River Bend Station - Unit 1

Docket No. 50-458

Enclosed for your review is Gulf States Utilities Company's (GSU) supplemented response to Question 210.101 concerning minimum wall thickness at girth butt welds from the Nuclear Regulatory Commission's (NRC) Mechanical Engineering Branch (MEB) consultant to Oak Ridge National Labs, E.C. Rodabaugh Associates, Inc. This response will be provided in a future amendment to the River Bend Station Final Safety Analysis Report.

210.101 In your Specification No. 228.000, "Specification for Piping Engineering and Design", Revision 1, dated 3/15/81 including Addenda 1 and 2, you have addressed the minimum allowable wall thickness at girth butt welds in piping. You have stated that the minimum wall thickness at girth butt welds is established by the counterbore requirements and it will be found on analysis that this value will not decrease to less than the manufacturer's minimum wall thickness requirements. Using a 12 inch schedule 160 pipe as an example you have provided the following example:

# AS BUILT DRAWING

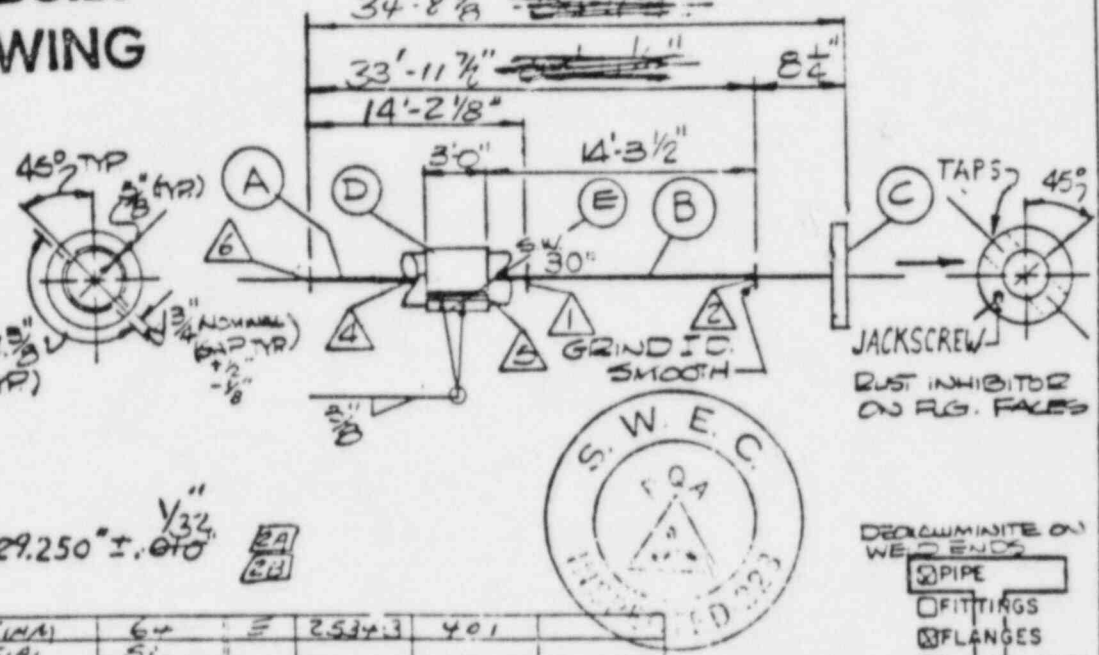
The use of C-dimensions as illustrated by your example, in conjunction with a pipe specification that has a tolerance of (minus)  $-1/32$ " on outside diameter (such as SA-106), would assure  $t_m \geq (7/8)t$ ; provided the counterbore is concentric with respect to the minimum outside diameter ( $t_m$  = minimum wall,  $t_n$  = nominal wall). If you do not control concentricity of the counterbore, explain how you are assured that  $t_m \geq (7/8)t_n$ . Include in the explanation consideration of 1) ANSI B16.9 fittings, 2) pipe specification SA-155, and 3) any other specification you use for ASME Code piping at River Bend which does not have the same minus tolerance on outside diameter as SA-106.

With some exceptions, for ASME Section III pipe with 26 in. and larger OD, the Stone and Webster Engineering Corporation Specification 228.150, Rev. 1, entitled "Shop Fabricated Piping" does not provide a specific minimum wall thickness or counterbore dimension. However, the specification requires the pipe ID be maintained at the nominal OD minus  $2t$  with a tolerance of  $\pm 1/32$  in. Where specific dimensions are given they were developed based on the methods described in PFI Standard ES-1, "End Preparation and Machined Backing Rings for Butt Welds". The calculations used to develop these counterbore and minimum wall dimensions include the tolerances given in the material specification (SA-155) except for out-of-roundness and off-center counterboring. However, as a guard against violation of required minimum pipe wall thickness the pipe fabricating is not allowed to violate the material specification minimum wall requirement unless specific approval is obtained from the engineers.

fabricator measures the actual wall thickness on all ends counterbored for field welding and records these readings on its shop traveler.

A quality control representative witnesses, on a surveillance basis, the dimensional checks to ensure that the counterbore of pipe is in accordance with the specification and that minimum pipe wall thickness ← Insert D has not been violated. In order to assure records on actual field end counterbores performed by the shop fabricator, the fabricator includes on his shop traveler the required and actual counterbore dimension as well as the required and actual pipe wall thickness after counterboring.
